**To:** Menlo Park City Council

**From:** Gary Lauder

**Re:** Changing 101/Willow Rd. interchange from cloverleaf to partial cloverleaf

**Date:** Tuesday, February 23, 2016 [\[and updated subsequently as noted below\]](#)

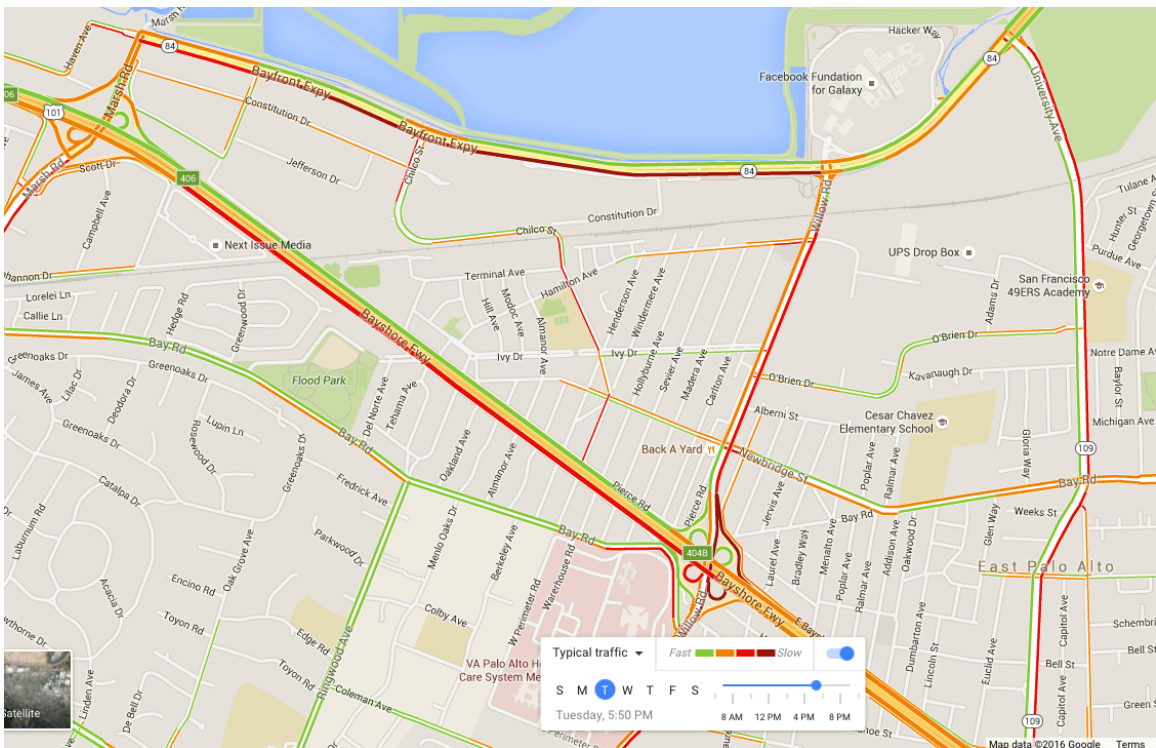
Page 14: "Northbound Route 101 off-ramp to eastbound Willow Road: Queues were observed to extend from the Newbridge intersection onto the off-ramp. The queue, however, was not observed to spill back to the freeway mainline."

At present, it spills back a full mile. The present traffic queue already exceeds the projections made for 2020. If the exiting traffic destined for westbound Willow were to be added to the existing queue, it would extend the queue beyond the University entrance ramp (and perhaps also the exit ramp). This would create a new hazard of crossover traffic, which has not been publicly evaluated.

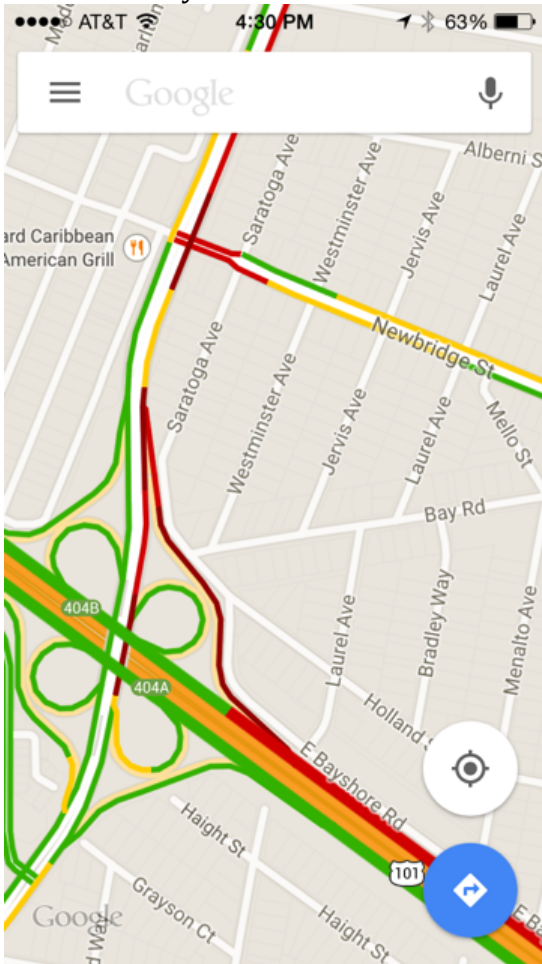
“The purpose of the project is to address the operational deficiencies of this interchange for all modes of travel and to reduce backups and upstream queuing on US 101. The need for this project is to reduce existing and expected traffic congestion in the vicinity of US 101 and Willow Road. **This congestion is being caused because of short weaving segments between loop ramps along US 101/Willow Road Interchange. These short weaving segments create weaving conflicts resulting in reduced traffic speed and increased upstream queuing and backups.**”

Anyone who drives this intersection knows that that is not the cause of congestion in this vicinity.

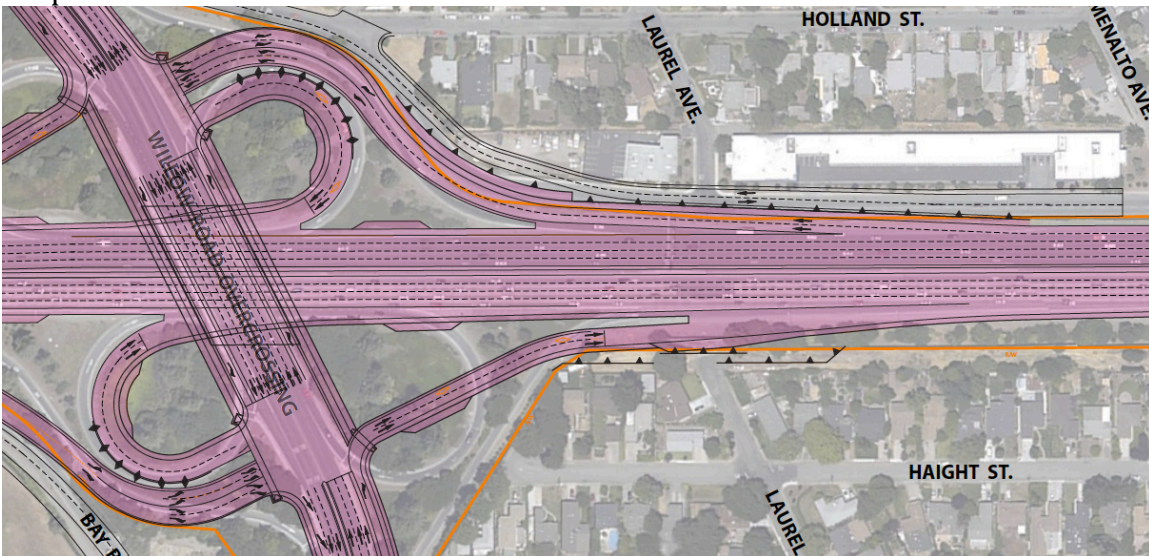
- 4) CalTrans claims that by having 2 right-turn lanes, it provides more "storage" for cars that are queuing that would reduce the backup to the highway. That might have been a valid claim back when the queue did not spill onto 101, but it's now a mile long. The planned incremental lane length looks to be <200', which is <4% of the maximum queue. The fact that officials still claim this shows that some form of delusion is occurring, either self-delusion or intentional. See close-up diagram extracted from larger diagram on next page:

Q: Do you really think that everyone headed east will stay in the right lane leaving the left lane clear for people turning left (west)? Q: Do you think that those who don't realize that the queue that starts a mile back at University Ave. and miss getting on the back of the queue will not attempt to exit at Willow and cut in (and therefore clog the west-bound exit lane)? Both questions can be answered by your

trying the Marsh Rd. [better: NB Hillsdale] exit at the PM rush hour. Hint: the answers to both are “no.”
